CITY OF GARDEN CITY

File Number: SUBFY2022-0001
For: Combined Preliminary and Final Plat processed as a Planned Unit Development
A 24-lot residential subdivision
Location: 511 E Remington Street
Applicant: Marty Pieroni of Treasured Communities, Inc.
Design Review: January 18, 2022
Planning and Zoning: January 19, 2022
City Council: February 14, 2022

Staff Report
Report prepared by Hanna Veal

Figure 1: Blue Line indicates identified pedestrian pathway system. Red Line indicates existing Greenbelt pathway.

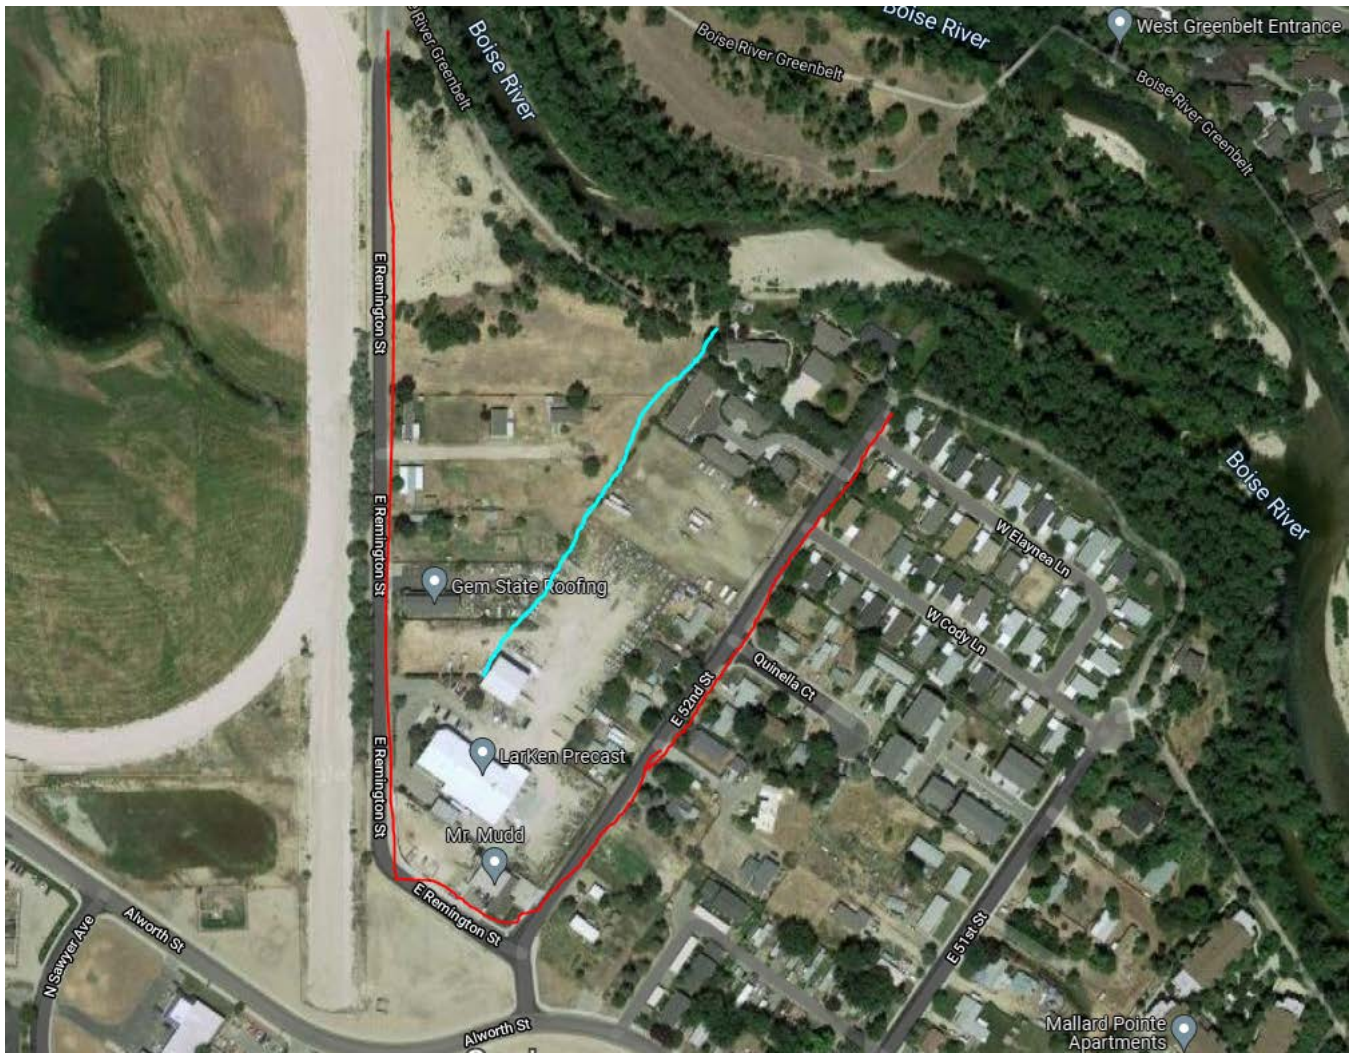
The city has identified a mid-block public pedestrian and bicycle access pathway that runs along the eastern property boundary line and is to connect with adjacent properties and eventually lead to the Greenbelt. Pedestrian pathway. [\(See Figure 1\).](#)

The subdivision proposes this connection; however, staff does not believe what is proposed meets pathway requirements as stated in Garden City Code 8-5A. A condition has been drafted to reach code compliance, it states, "The easement for the pathway shall be a minimum of twelve feet (12') wide, with at least a ten foot (10') wide prepared travel width."

The pathway is not completely linear and does not have an obvious connection or markings to indicate where the pathway travels once it intersects the common drive. If the Committee/Commission feels that a more obvious connection is needed, a condition will need to be drafted. For example a condition can be drafted to require painted white stripes where the pathway traverses the common drive;

As proposed, the pedestrian pathway terminates at the southern property boundary line in a location that which might make it difficult to make future connections to adjacent properties. A better design to maximize potential connections would be to require the pathway to follow a more linear trajectory along the eastern property boundary line and terminate at the southeast corner. An alternative condition staff might recommend would be to relocate or shift the drainage swale in order to provide a more linear and direct pedestrian pathway along the eastern property boundary line.
